| <b>AMENDED</b> <b>SUNDRY NOTICES AND REPORTS ON WELLS</b>   |  |
| 2. NAME OF OPERATOR<br>Marbob Energy Corporation  | 8. FARM OR LEASE NAME<br>M. Dodd "B"                       |

This will amend our sundry notice dated 4/23/85.

## SUP Exhibit "D"

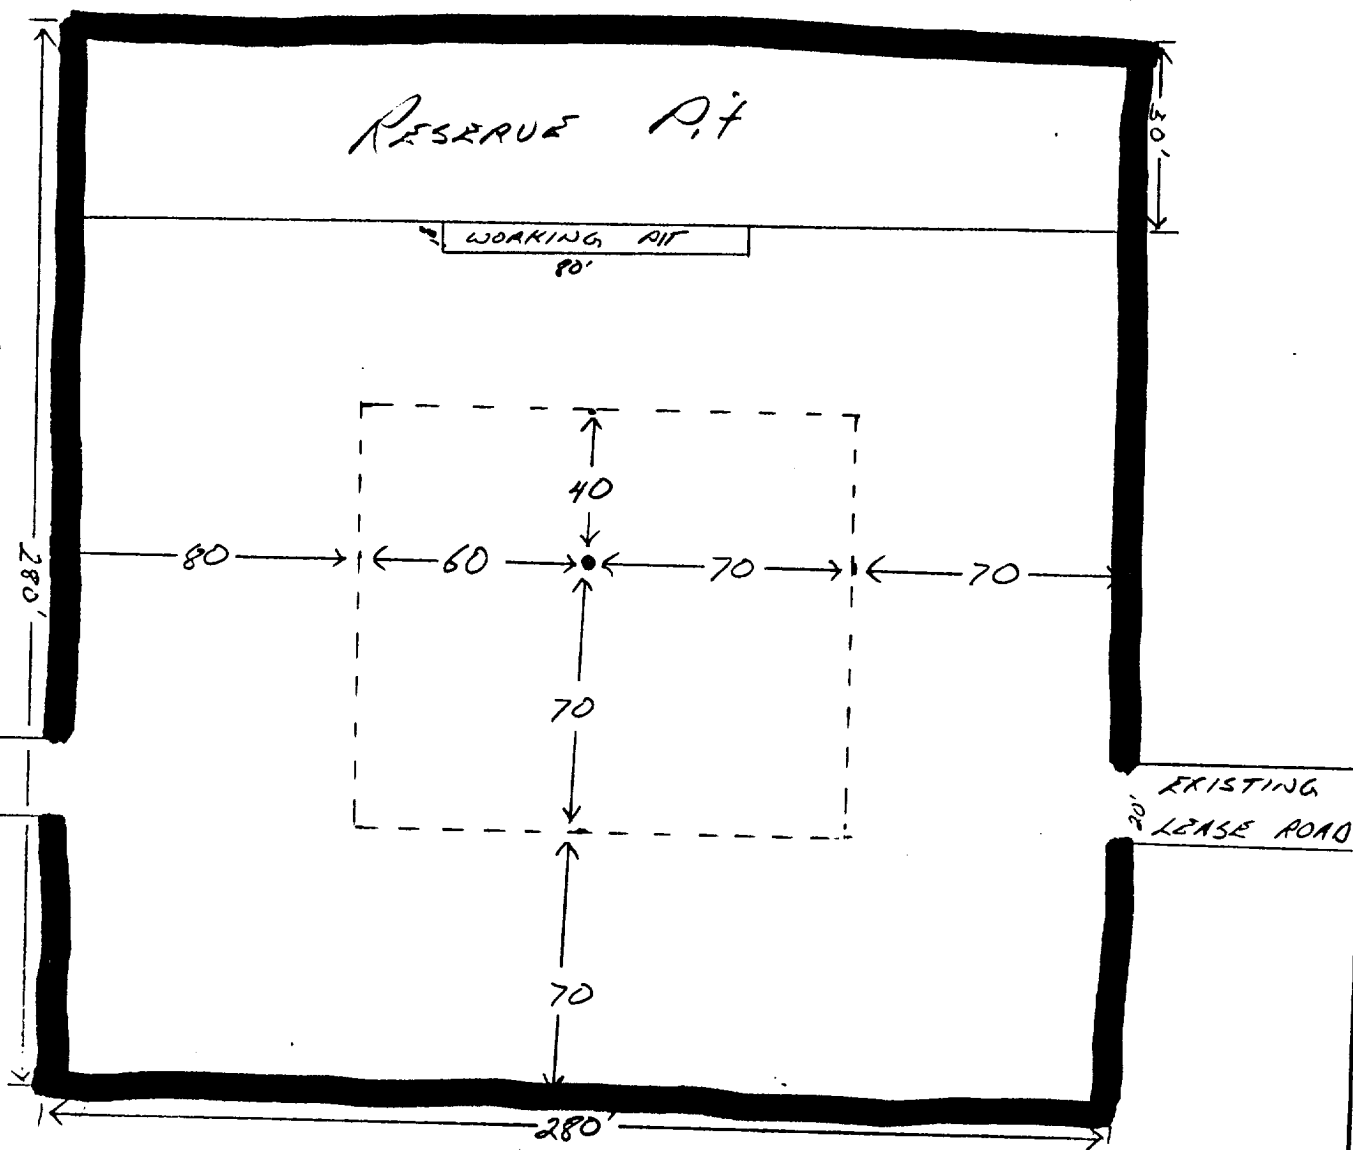
We propose to deepen this well from its present depth of 2550' to 4500'. w/Larue Drilling Rig #2. 7" pipe was run to 2284'. A 6 1/2" hole will be drilled. We will run temperature survey to find top of cement; squeeze to base of salt; perforate at top of salt; squeeze cement inside surface pipe or to surface; drill to 4500' and run 4 1/2" 11.60# J-55 new casing to TD and cement. The existing well pad will be extended to 280' x 280' as shown on the attached exhibit.
